CERTIFICATE OF APPROPRIATENESS

Property: 811 Hemphill Street, Tract 7, Block 396, Baker W R NSBB Subdivision. The property includes a historic 784 square foot, one-story wood frame single-family residence situated on a 2,069 square foot interior lot.

Proposal: Alteration – Construct two sets of front steps (a set on either side of the porch)

CODE ENFORCEMENT DRAWINGS
(PROPOSED HANDRAIL SPECIFICATIONS)

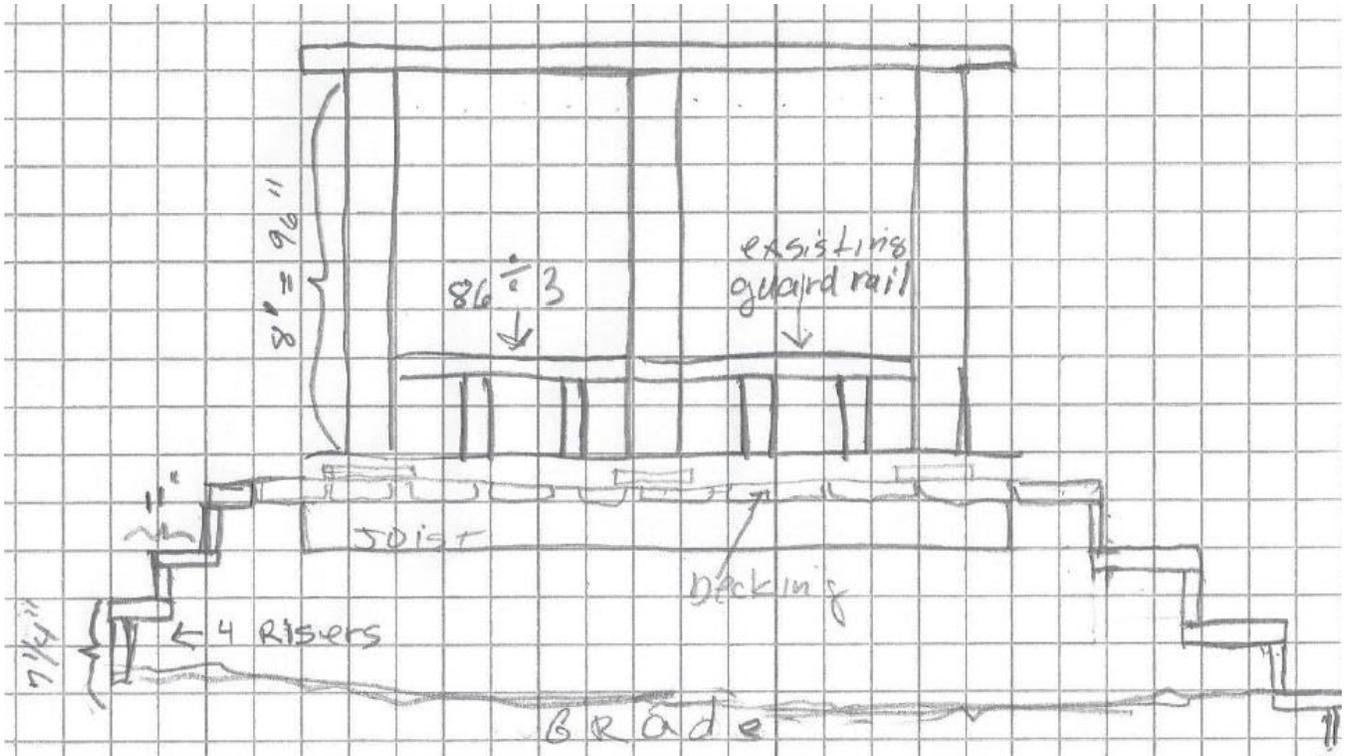
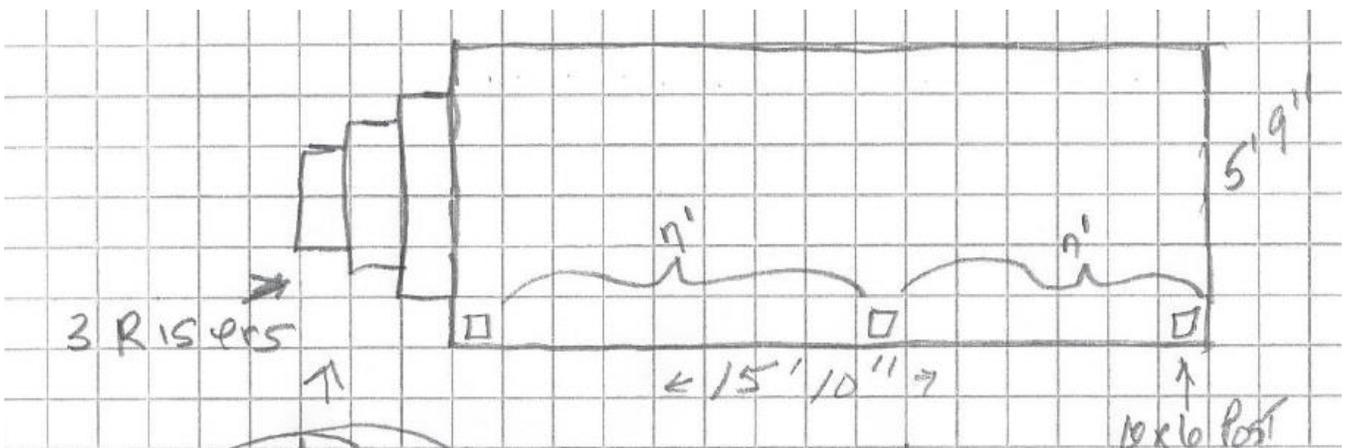
PROPOSED STEPS

The applicant proposes to construct a new set of steps that meets the required code. Each tread will be 11" in depth and each riser will be 7¼" in height. As proposed, the steps are four risers high and require a handrail; the handrail will need to meet code requirements. The handrail will be a 34" in height and will not include a balustrade (intermediate rails). The proposed stairs and handrail will meet City of Houston Building Code. The existing guardrail, porch columns, porch flooring and roof is to remain. See drawings and photos for more detail.

311 REPORT PHOTO

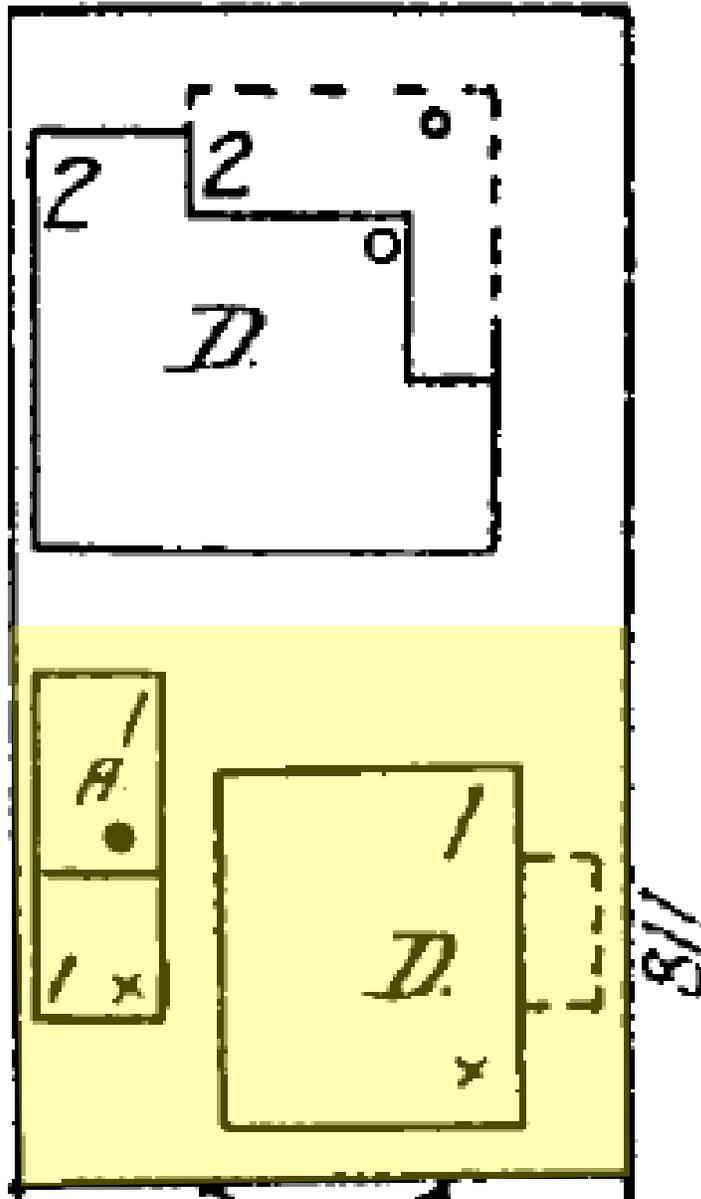
A Red Tag was issued on February 23, 2016, for doing work without a permit and to obtain all necessary permits.

A second follow up Red Tag was issued on March 8, 2016.
